June 30, 1999

**WASHINGTON SMB-1393**

**Decommissioning Plan,**

**Part 1 Revision**

**Figure 2-3a - Location of Total Thorium Concentration Exceeding 30 pCi/g—including Subsurface Molycorp, Inc. Washington, PA Facility**

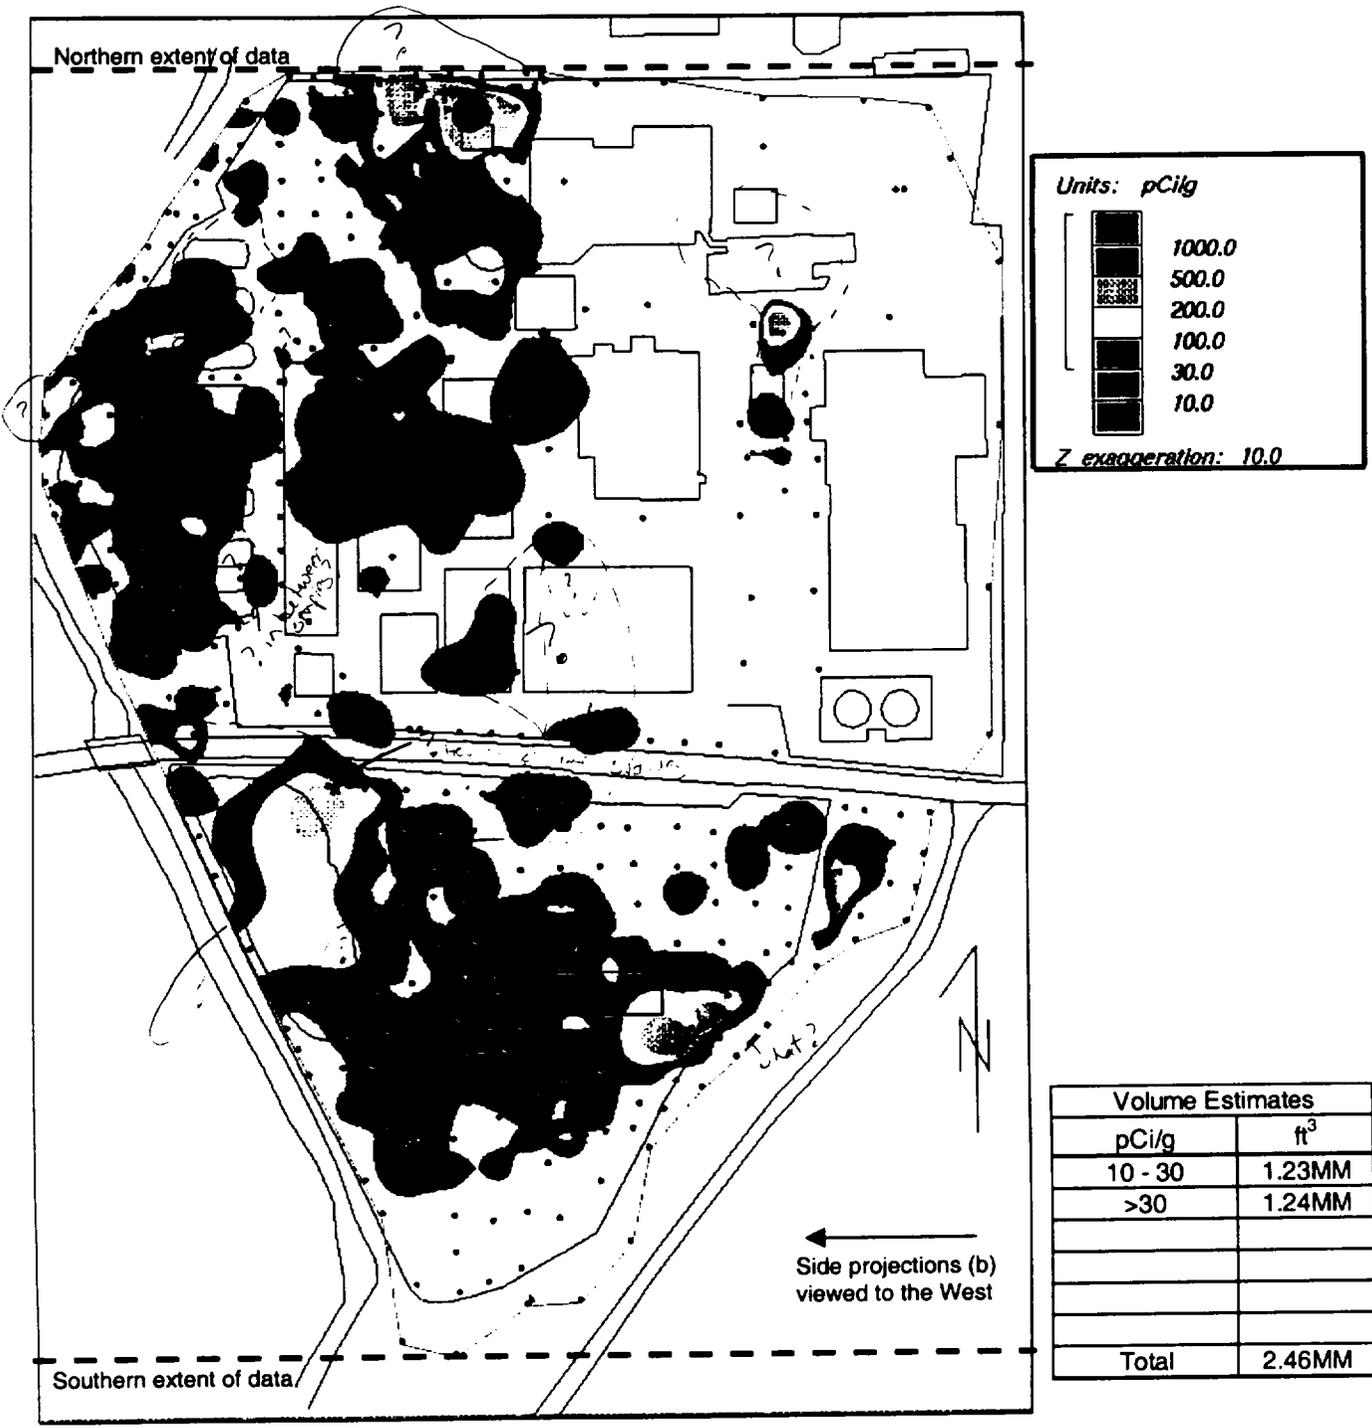
\* Contaminated  
 \* Area shown to be  
 50' of 10' of 10'  
 \* NOT A conservative (Groundwater)  
 method of contour construction

**Figure 2-7a - Location of Total Thorium Concentration Exceeding 1000 pCi/g—including Subsurface Molycorp, Inc. Washington, PA Facility**

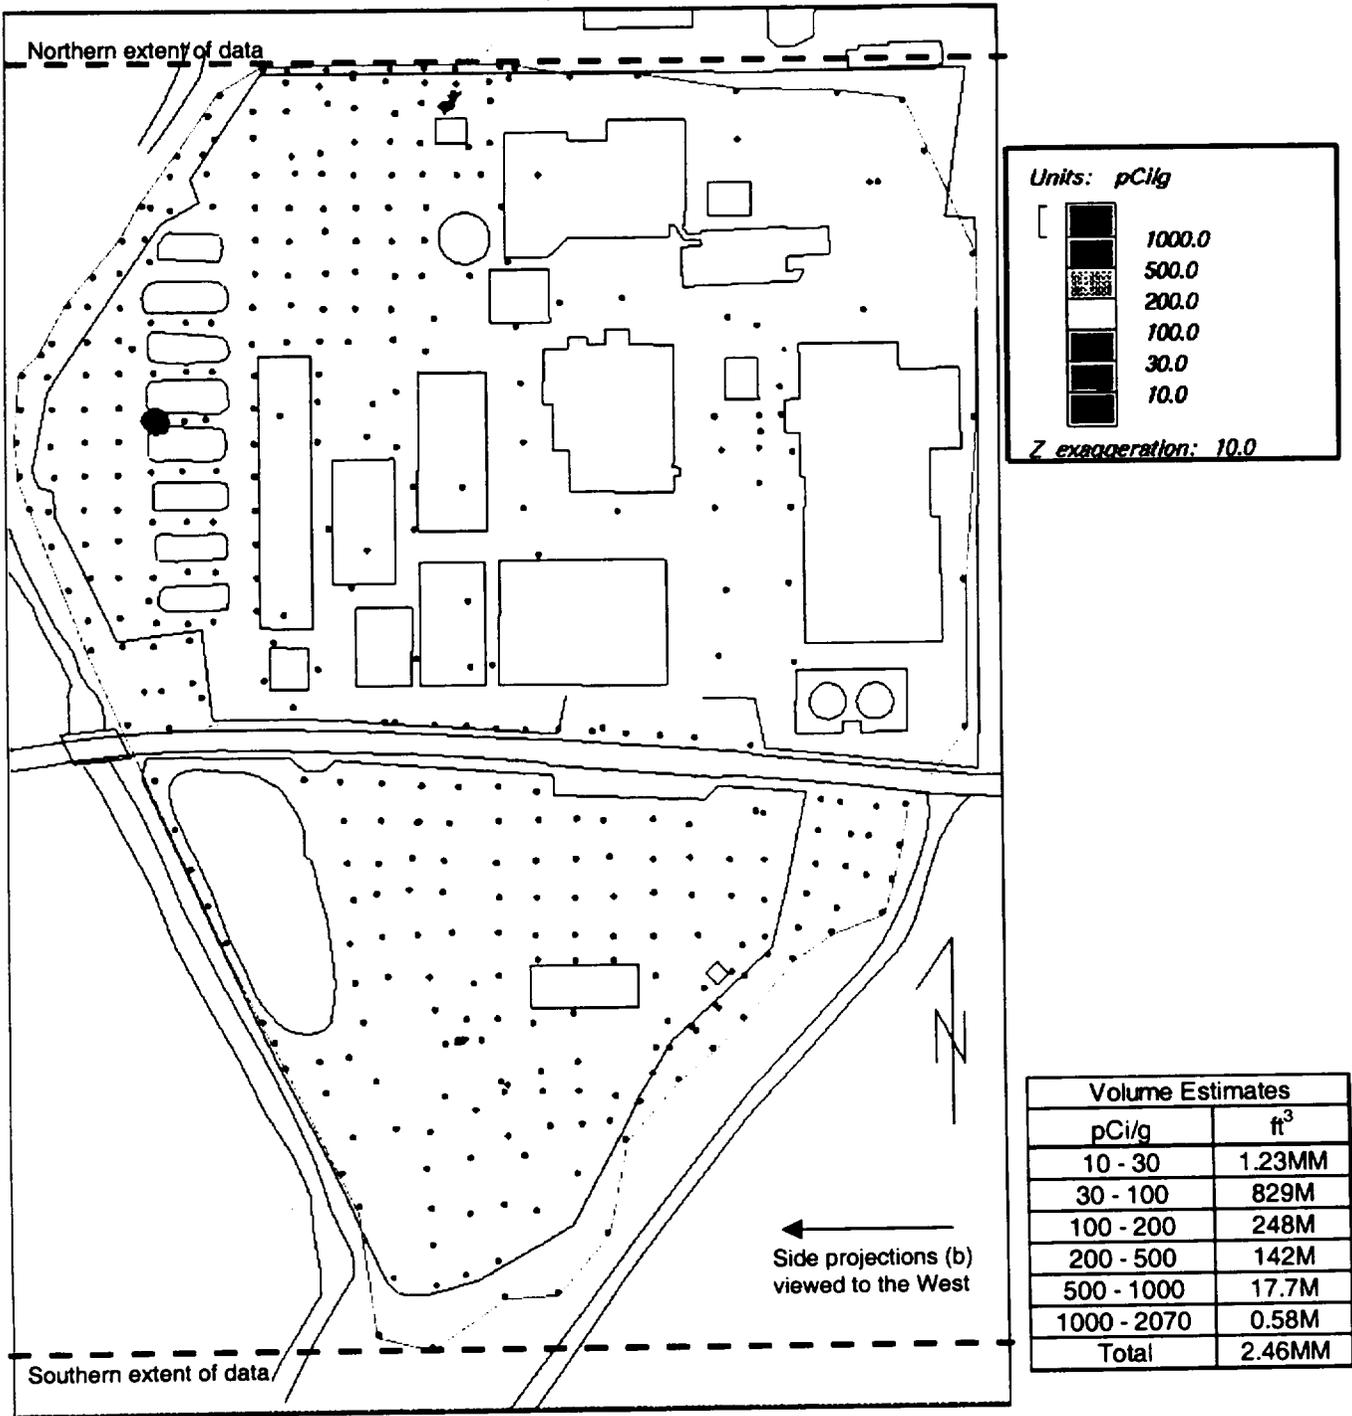
*reference to diagram*

FIGURE 2-8  
MAJOR CONSTRUCTION TASKS & SEQUENCE

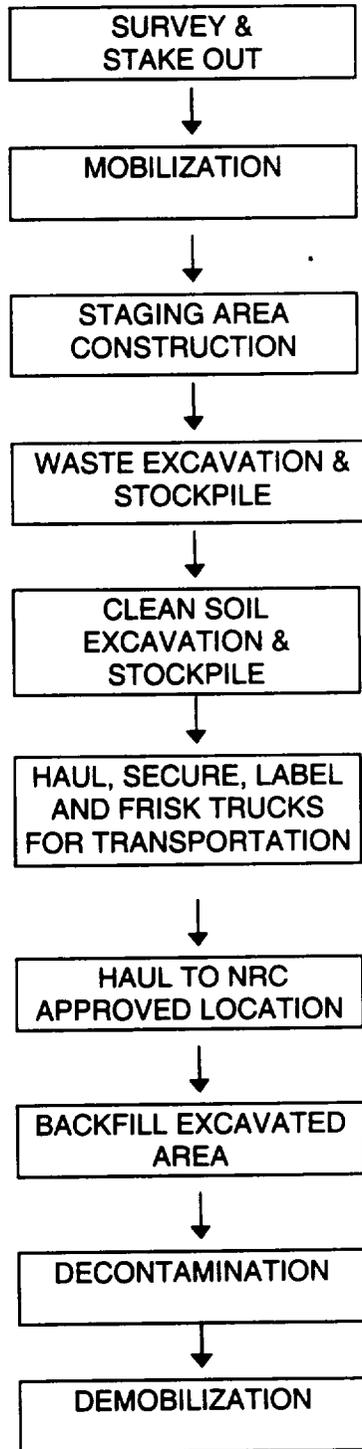
\* Need  
to make  
Distinction  
between Parts I  
& II.

→ they mean O.D.C. I  
so why are they  
looking for defects.
